CITY PLAN COMMISSION STAFF REPORT

Cookingham Development – Expansion

CD-CPC-2025-00024
Rezoning without Plan
CD-CPC-2025-00025
Area Plan Amendment
CD-CPC-2025-00026
Development Plan – Non-Residential

Case Number: CD-CPC-2025-00026

FUTURE THOROUGHFARE WITH 33' RIGHT-OF-WAY SOUTH SECTION - NW COOKINGHAM DRIVE
SCALE: 1" = 5'-0"

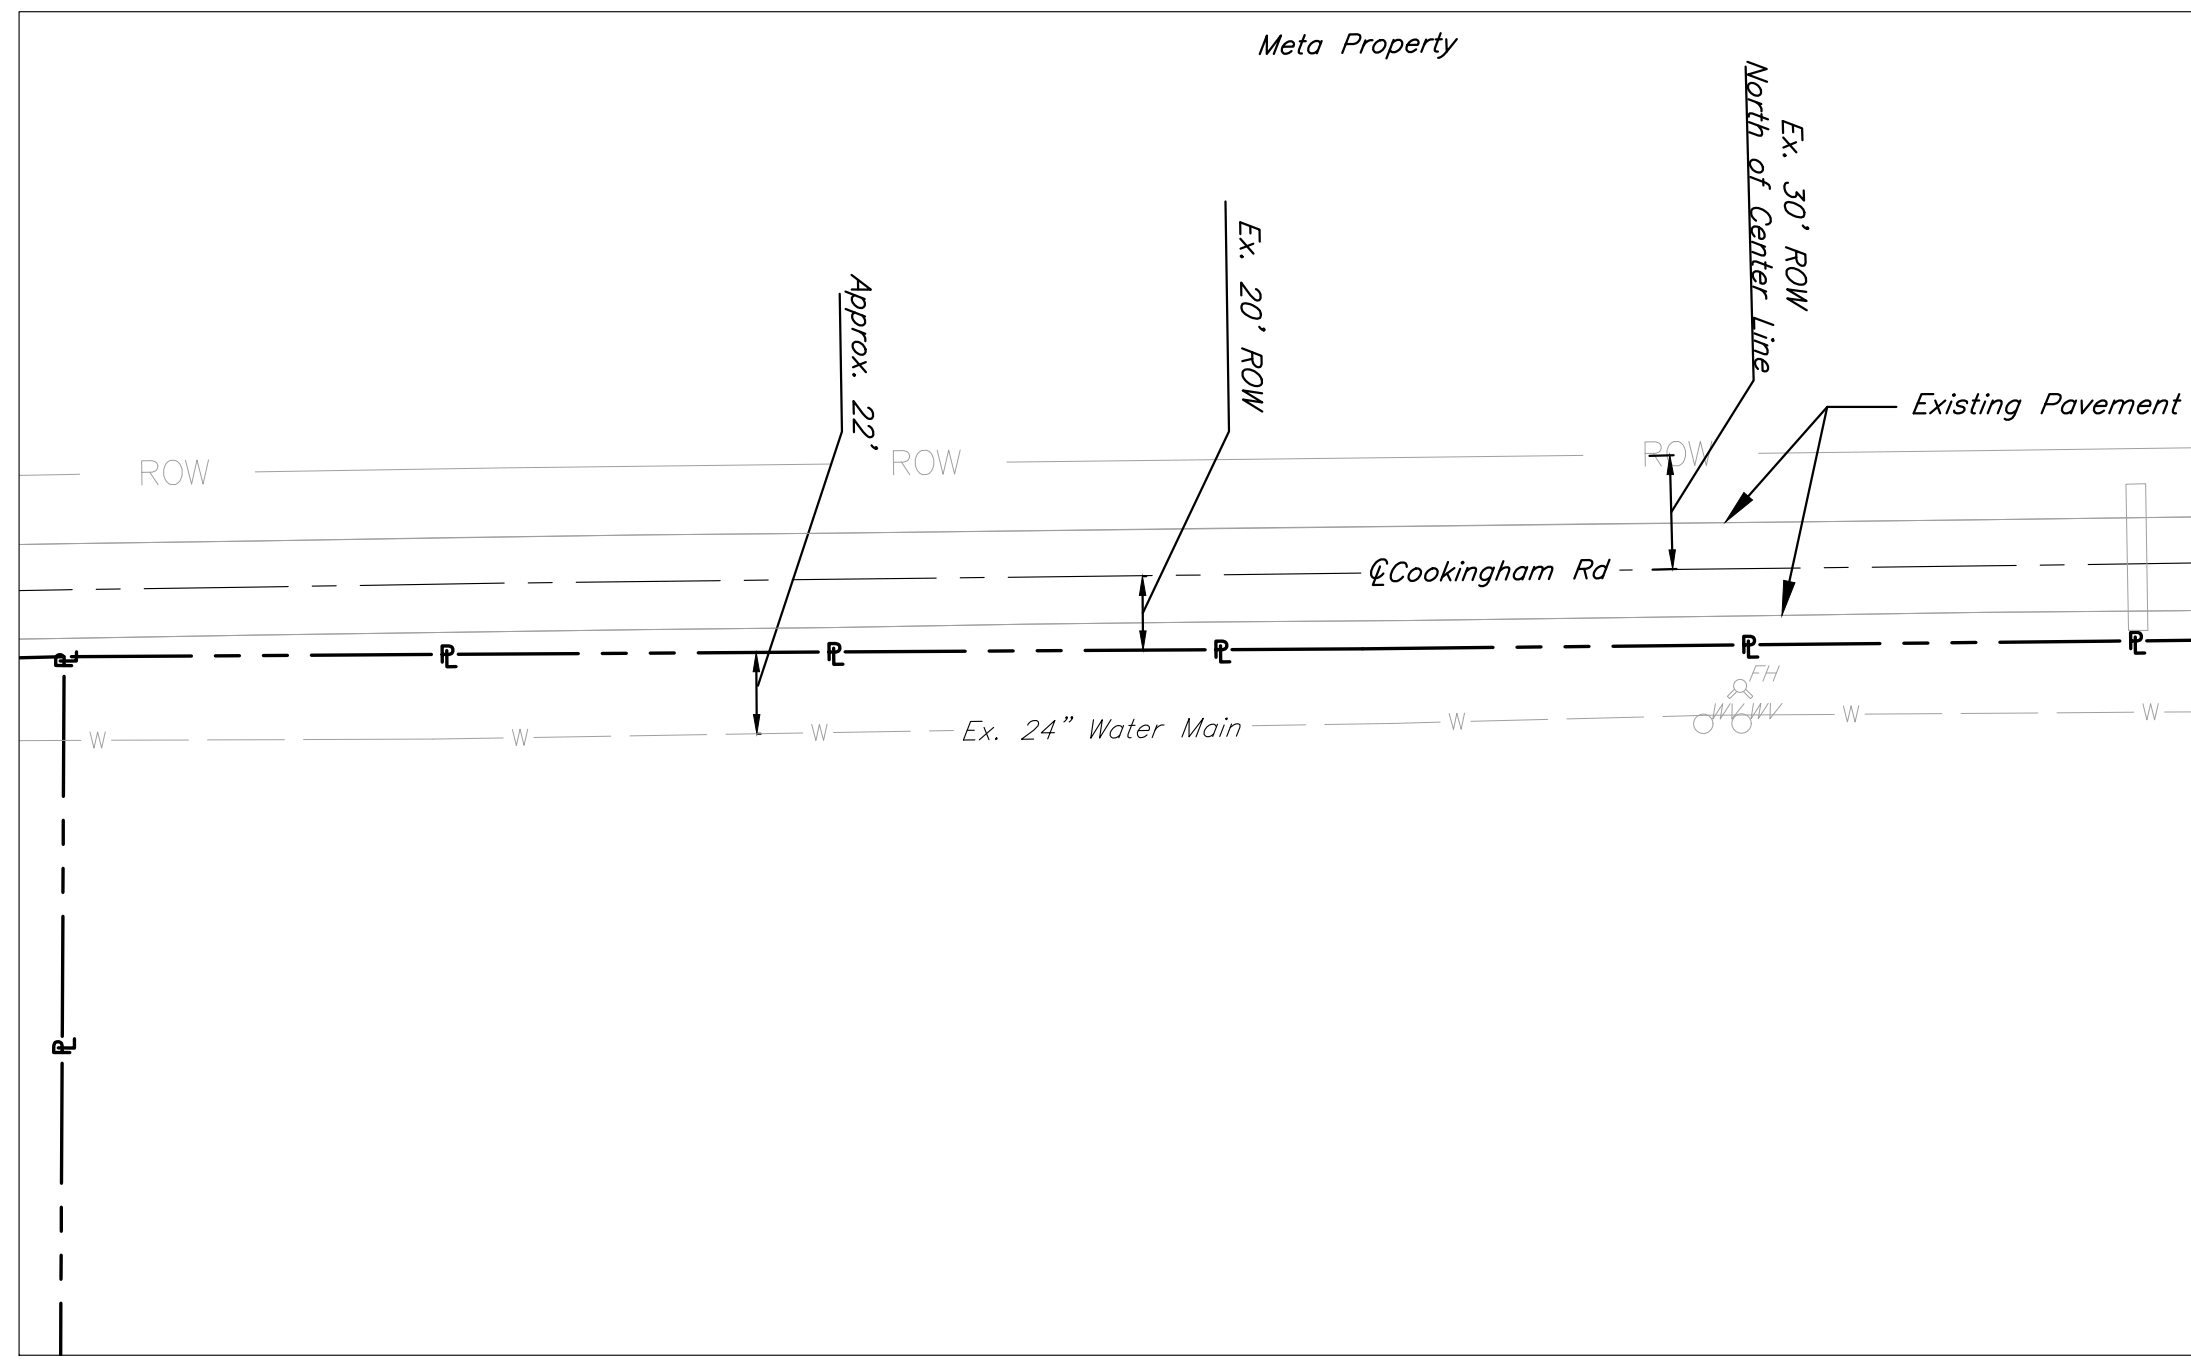
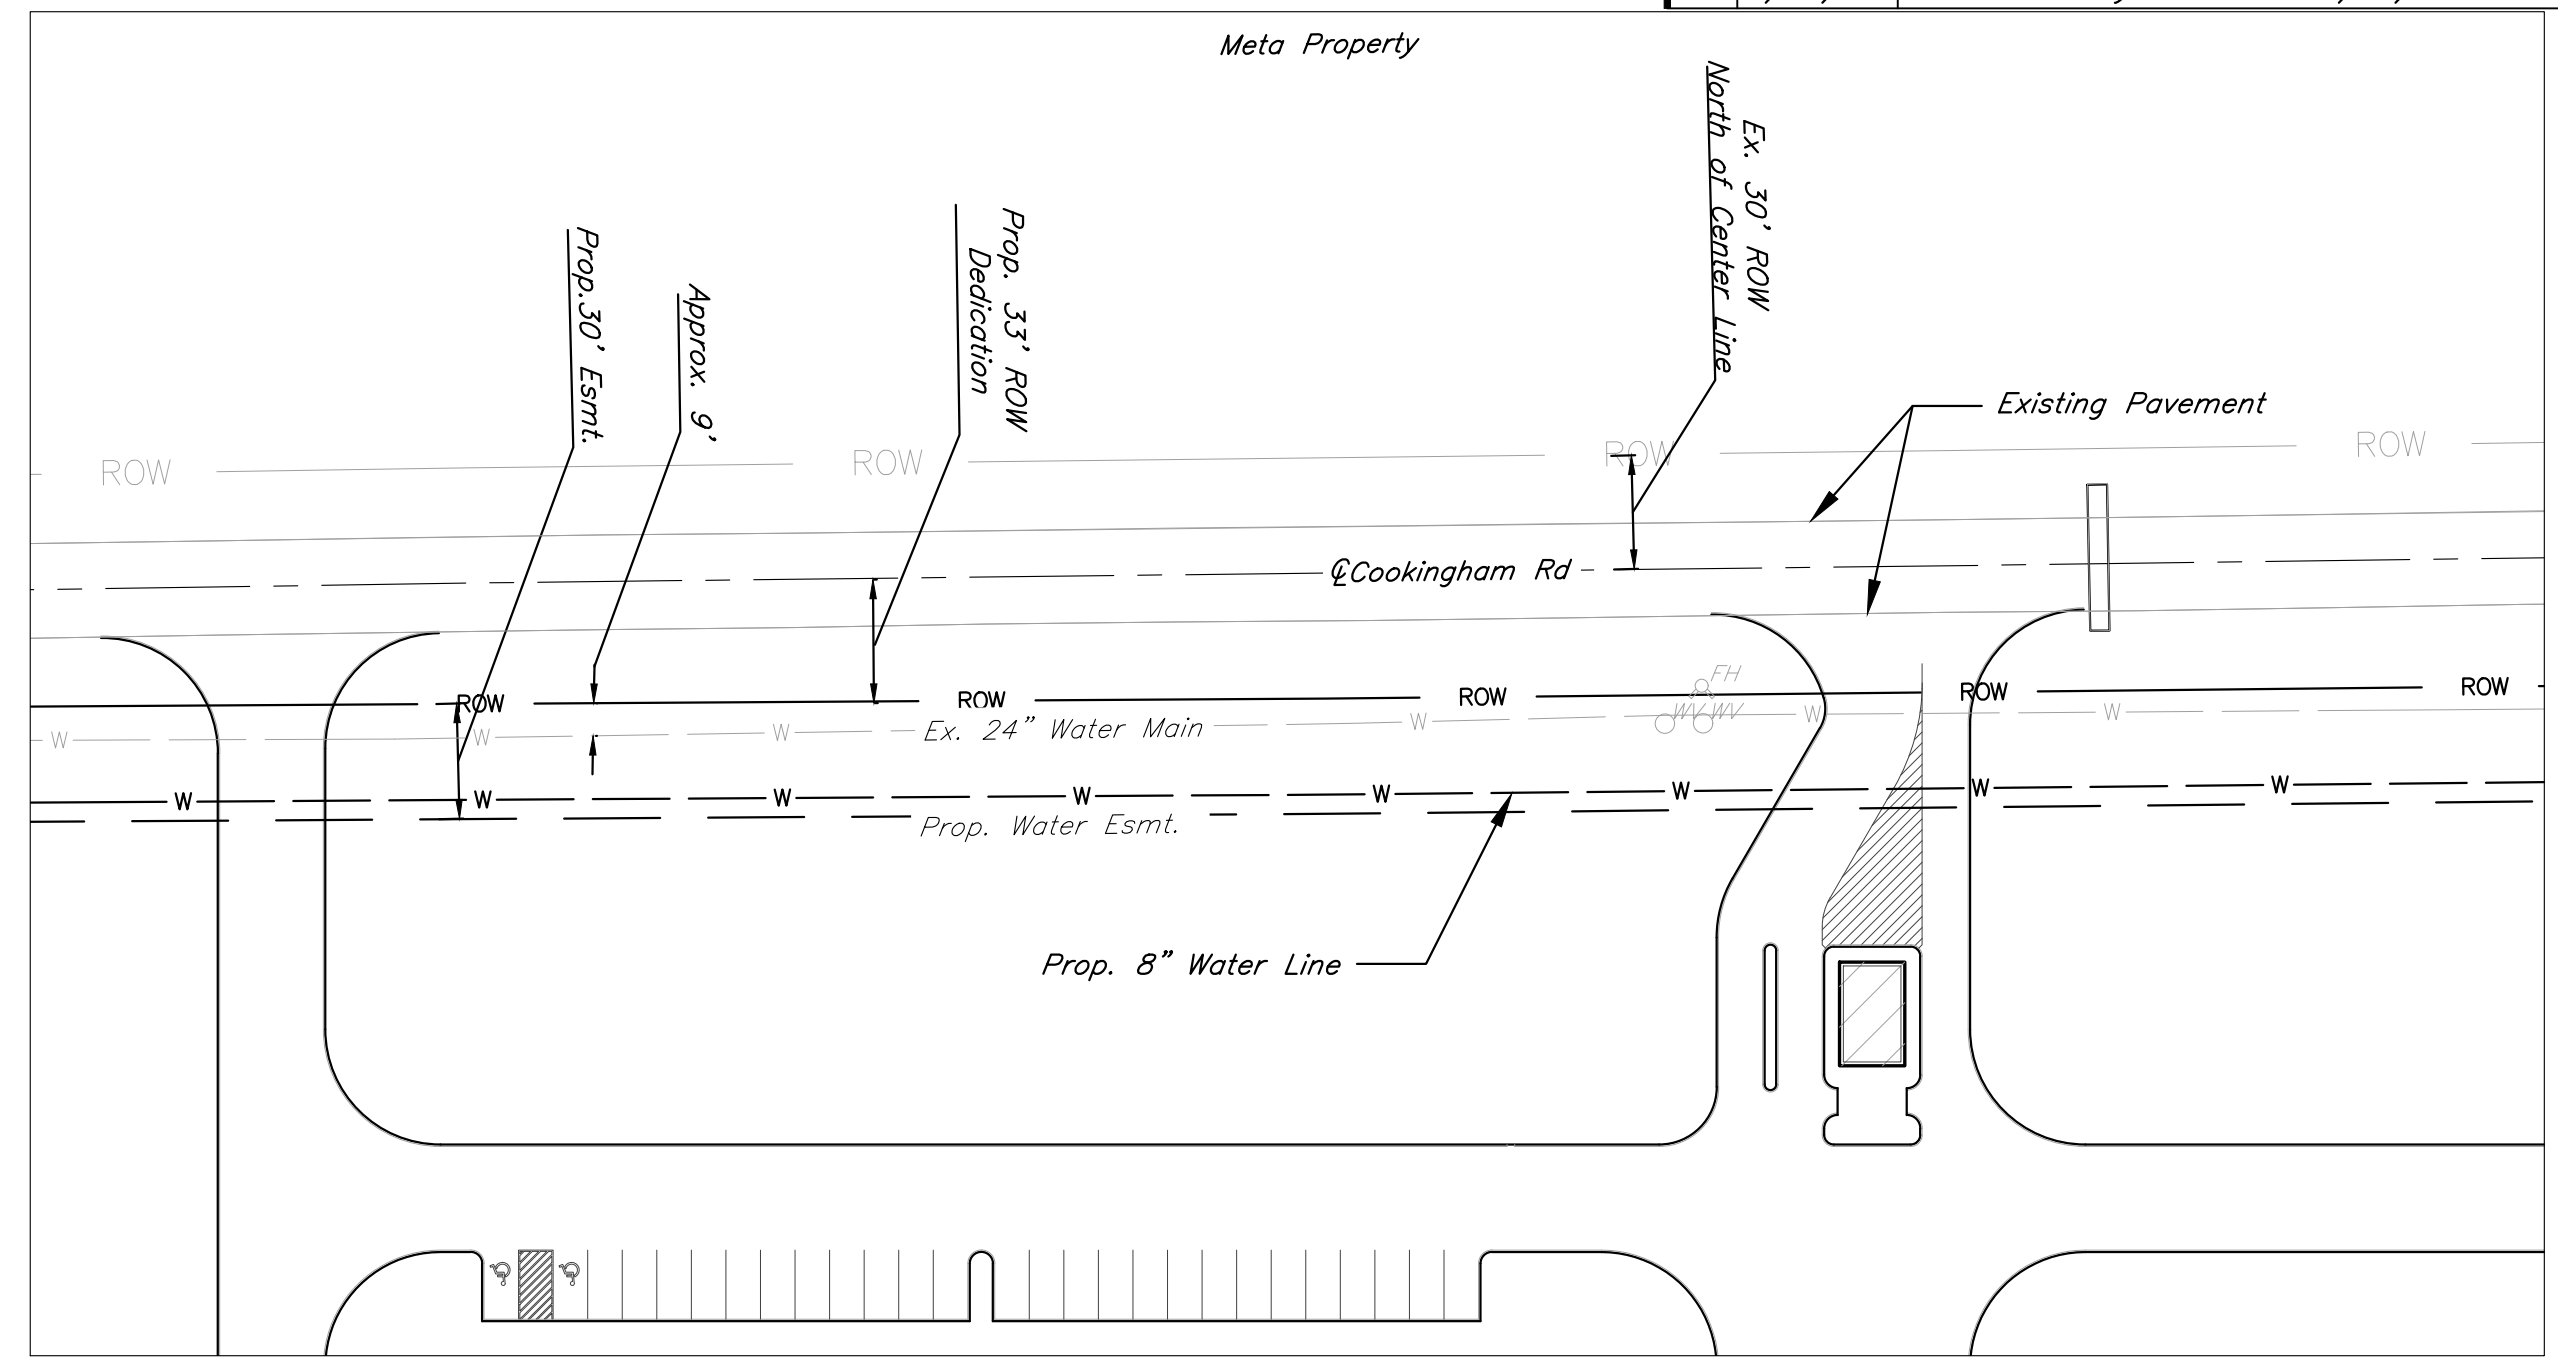
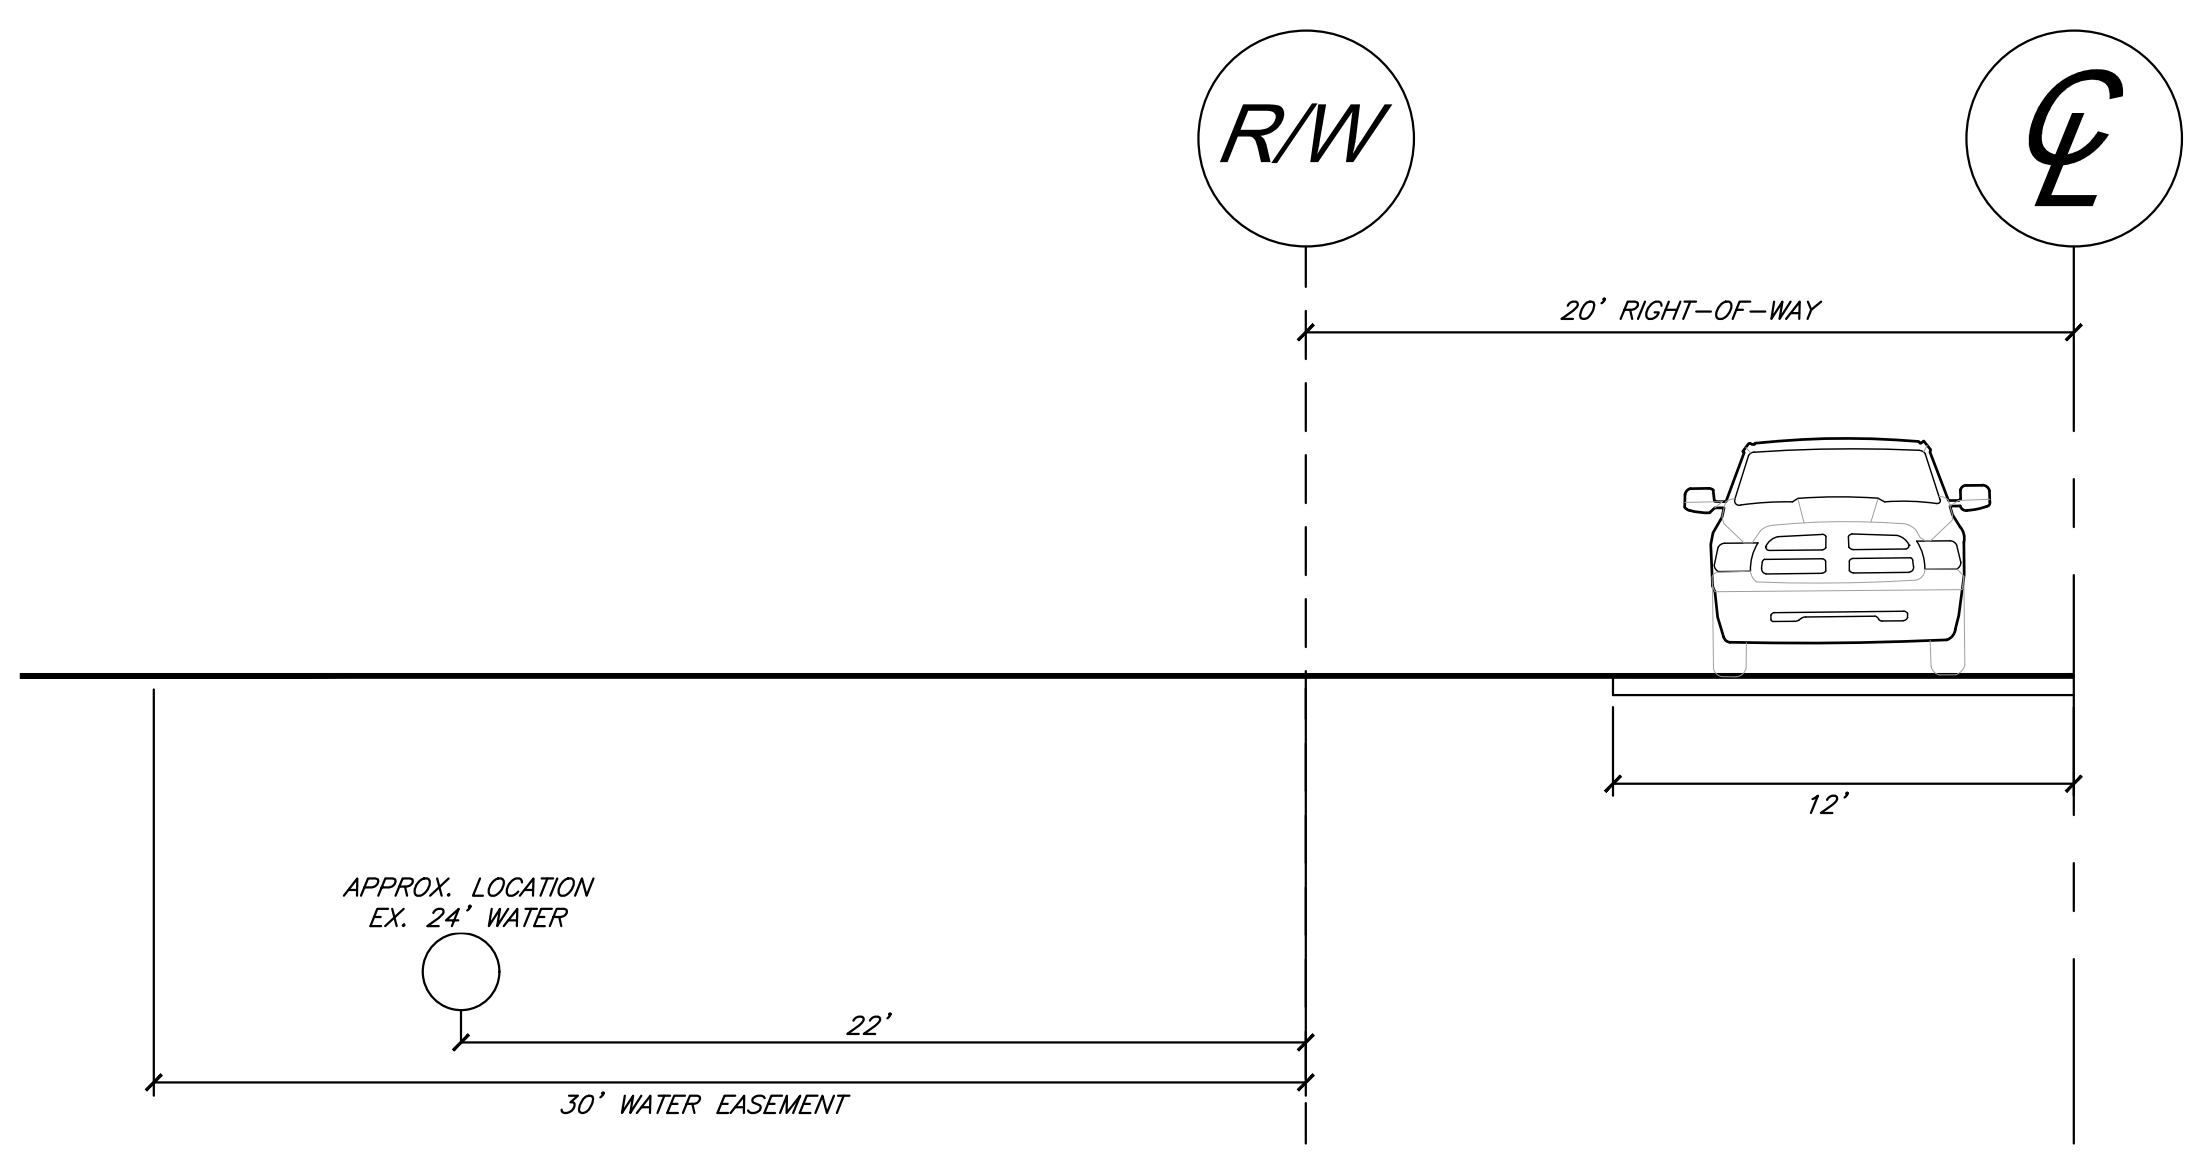
KC Water and the Public Works department have asked the applicant shall confirm that they are providing the correct amount of right-of-way to allow for future improvements to NW Cookingham Drive.

7. The developer shall dedicate additional right of way [and provide easements] for NW Cookingham Drive as required by the adopted [Major Street Plan and/or Chapter 88] so as to provide a minimum of 60 feet of right of way as measured from the centerline, along those areas being platted.
